SERVICE BULLETIN

NO. **113A** DATE **2-3-99**

McDONALD'S VERTICAL CONTACT TOASTER (VCT-200) (P/N 7000202 Chain Guard & Wire Set Update Kit)

This bulletin supersedes SB113 dated 12-15-98. SB113 requested the (P/N 7000202) chain guard and wire set kit be installed on all McDonald's Rapid Toasters, model VCT-200, shipped between July 1, 1998 up to December 31, 1998 on an "as needed" basis. The serial numbers for these units are 0807_ _ _ _ up to 0812_ _ _ _ . (NOTE: Toaster serial numbers usually consist of 8 digits. We had a software glitch with our serial numbering machine and it would occasionally drop off the first digit. Therefore, the serial numbers of some of these retrofit units will consist of only 7 digits and start with an 8 instead of 0. They will read 807_ _ _ _ up to 812_ _ _ _ .)

Figure 1

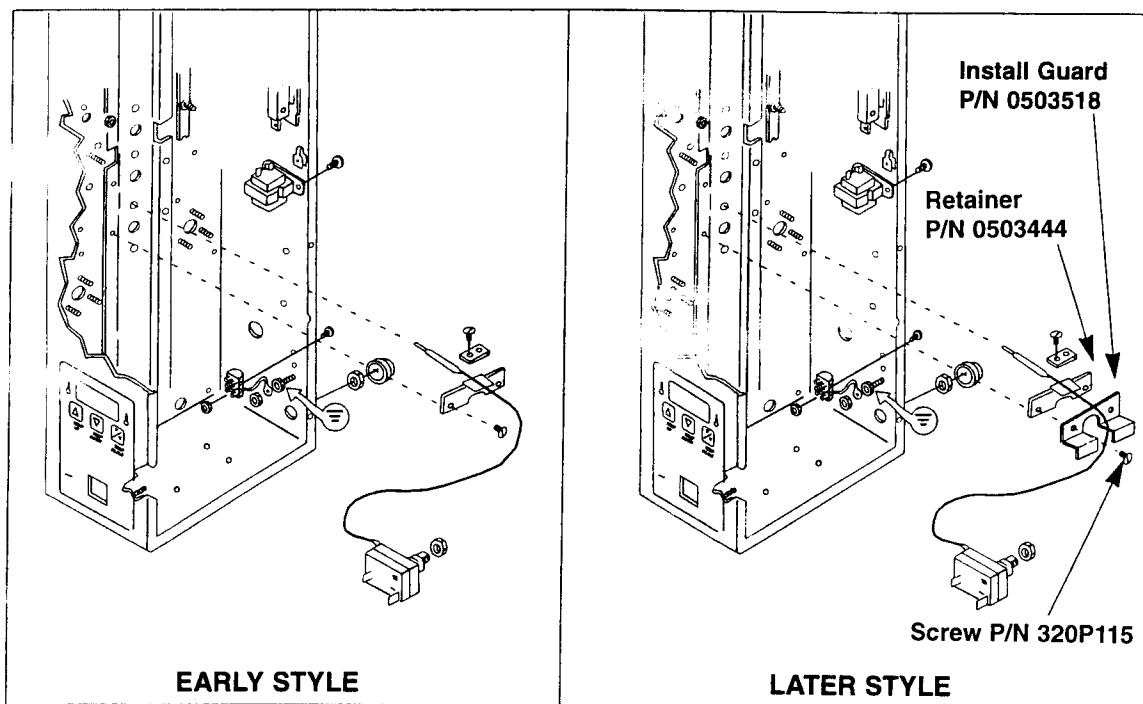
1. (P/N 0503518) Chain Guard: We have found that after the toasters have been in operation for several months, the drive chain stretches. Occasionally the chain will jerk or bounce. This jerking or snapping in turn can permit the chain to rise and touch the lower 200-volt connection of the platen heating element. Installing the chain guard eliminates this situation.

1. Turn power switch off and disconnect all electrical power from toaster.
2. Remove right side control cover (P/N 0503414).
3. Remove both screws (P/N 320P115) that fasten the high limit capillary retainer (PN 0503444) to the frame of the toaster. (Do not remove the top plate of the retainer)
4. Slightly lift the high limit capillary.
5. Starting from the right side of the control cabinet, thread the new chain guard (P/N 0503518) in between the capillary tube and the white wires going to the lower platen terminals.
6. Align the holes of the chain guard (0503518) with the corresponding holes of the retainer.

**FIGURE 2
BUSS BAR REPLACEMENT**

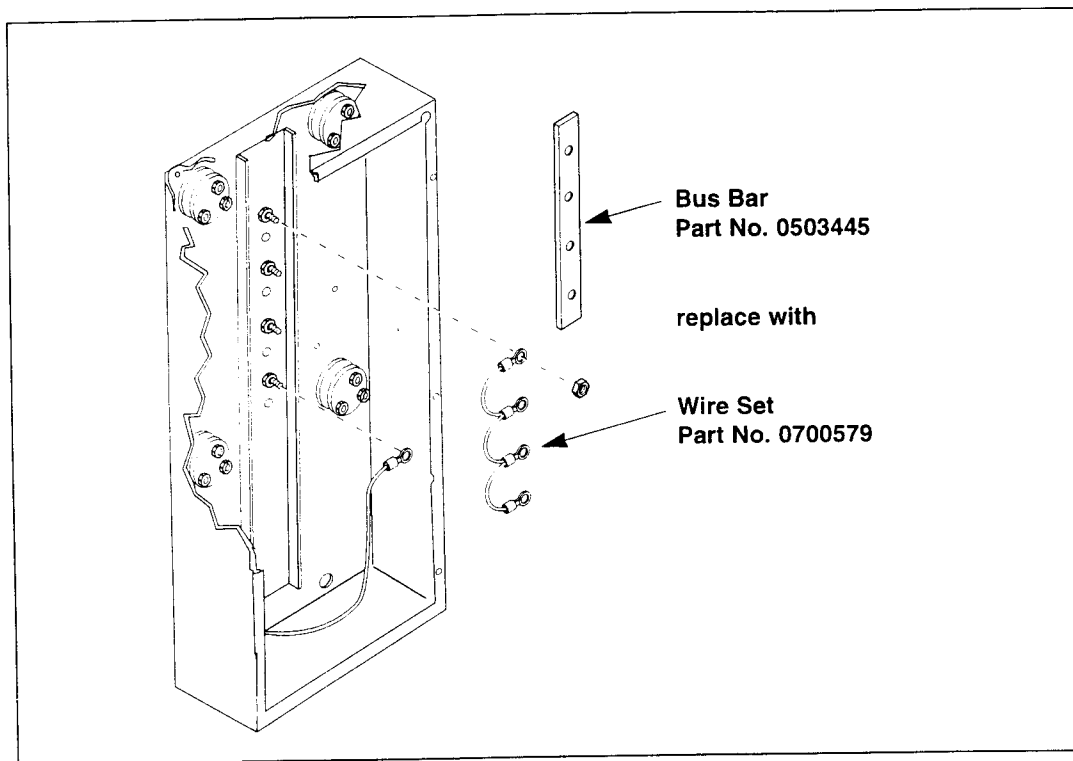
2. (P/N 0700579) Wire Set: The buss bar (P/N 0503445) is connected to all four return element legs of the platen. These legs usually have different lengths. This has caused stress on the buss bar, which in turn permits the nuts to loosen and cause a loose connection. The wire set eliminates this situation.

- 1) Turn toaster off and disconnect all electrical power to the toaster.
- 2) Remove both knobs (P/N 2100253) from the tensioners located on the left side of the toaster.
- 3) Remove the left side cover (P/N 0503416).
- 4) Remove the Buss Bar (P/N 0503445) and discard (See Fig. 2).
- 5) Install the wire set (P/N 0700579) as shown in Figure 2.
- 6) Turn power on and test.
- 7) Replace side cover and tensioner knobs.

Figure 1. Replacing Drive Motor and Fan Blade

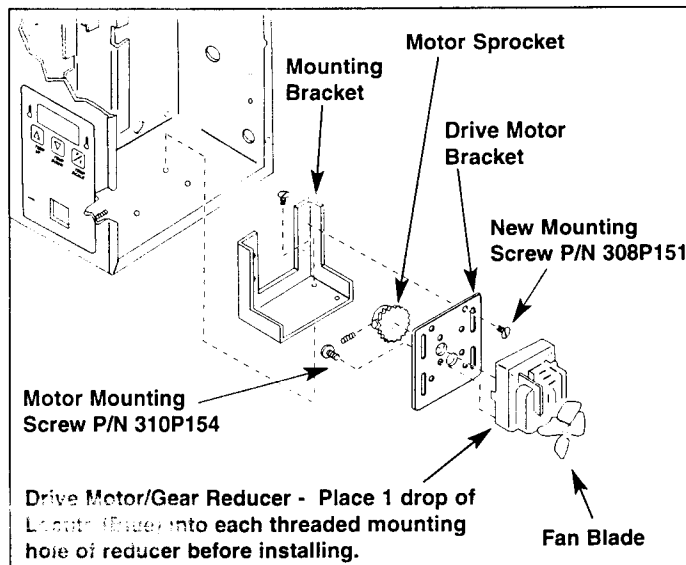
3. (P/N 7000175) Conveyor Motor Replacement: We have experienced problems with some of the conveyor motors therefore we have made a corporate decision to replace all the conveyor motors made within the same time period that is being covered with the chain guard and wire set retrofit. Installation of the new motor mounting screws (P/N 308P151) will prevent the motor from creeping up under use. Please return the old motors to the factory with your reimbursement forms.

1. Disconnect the motor wires and remove the drive motor and drive motor bracket (Figure 1). Discard the four 10-32 x 3/8" mounting bracket screws.
 2. Remove the motor sprocket using a hex wrench.

Figure 1. Identifying Motor that MUST Be Changed

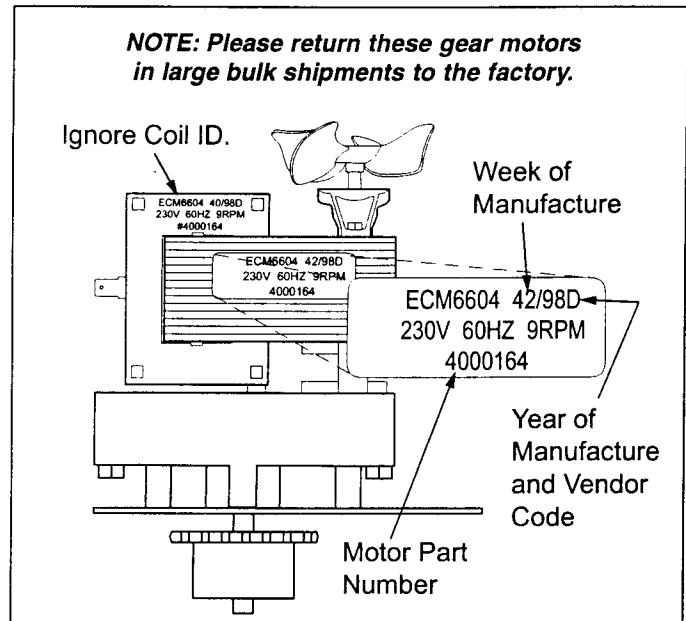
NOTE: ONLY MOTORS MANUFACTURED PRIOR TO WEEK 3 OF 1999 REQUIRE CHANGING. MOTORS MANUFACTURED FROM WEEK 3 OF 1999 AND LATER FEATURE THE IMPROVED DESIGN AND SHOULD NOT BE CHANGED. SEE FIGURES 1 & 2 FOR MOTOR IDENTIFICATION.

**Figure 2. Identifying New Improved Motor
DO NOT CHANGE**

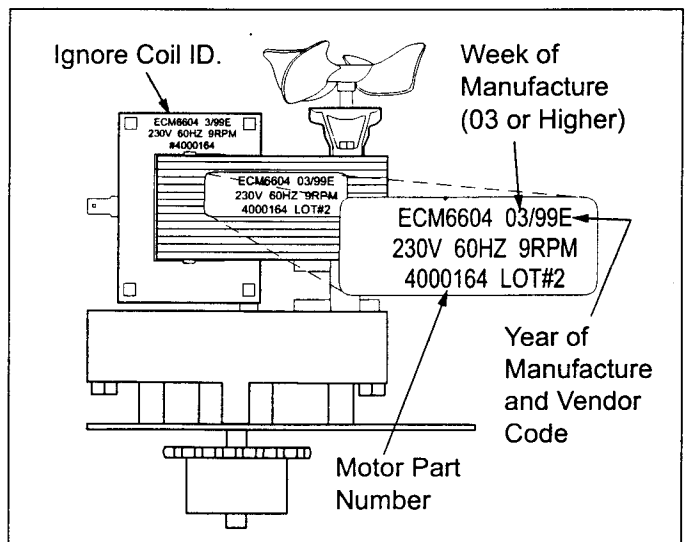
It is very likely that you will encounter VCT-200's in the field built with the new motors. DO NOT CHANGE THEM! Please state on the Conveyor Verification Form [Project Warr 0199](#) that the motor was changed previously.
